RE: Sharon W.S.C.

Application to Amend Water CCN (10476) PWS 1D# 2500020 Upshur County, Texas. Docket #44816 – Order No. 8

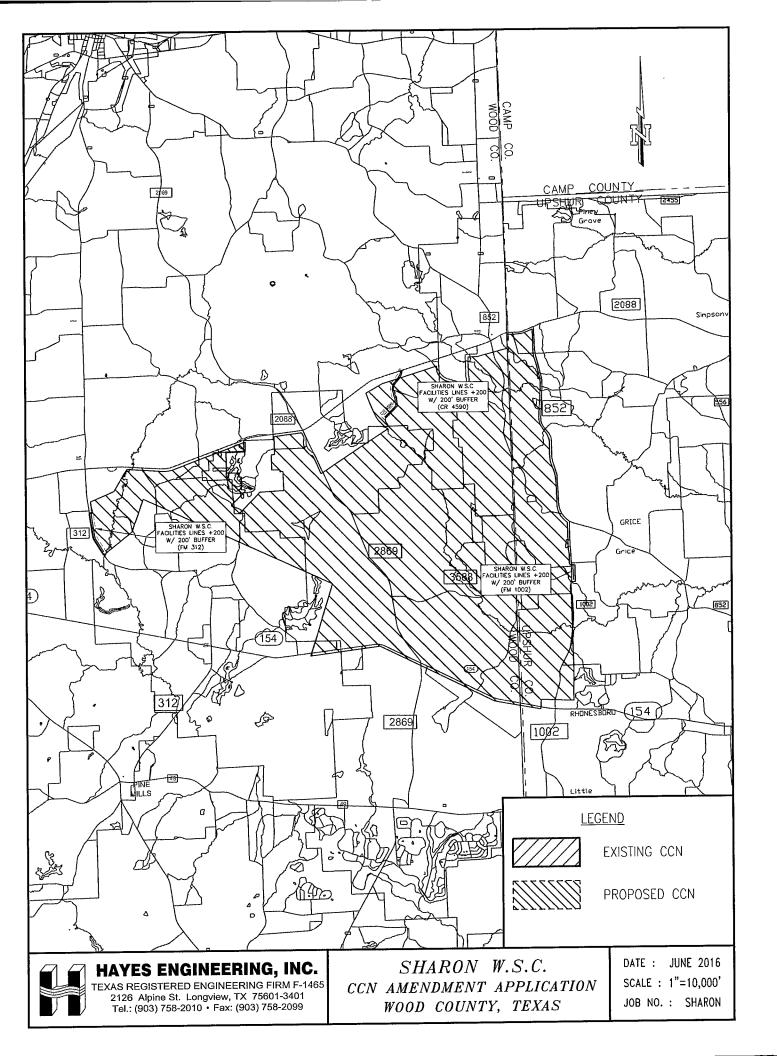
We received Order No. 8 May 14, 2016 that there were some insufficient details that needed to be corrected on the mapping requirements. I spoke with Tracy Montes, and she fixed the overlapping issues we were having and informed me about the facility +200 lines. Below are the facility +200 lines we are including in Sharon WSC proposed CCN area.

- The intersection of FM 2088 and CR 4590, Sharon WSC facility +200 line on CR 4590 is now incorporated into the proposed service area.
- On FM 312, south approximately 4,300 feet south of FM 2088, Sharon WSC facility +200 line is now incorporated into the proposed service area.
- The intersection of FM 1002 and Lamb Road, Sharon WSC facility +200 line is now incorporated into the proposed service area.
- The new total area after incorporating three (3) of Sharon WSC facility +200 lines is approximately 21,328 acres.
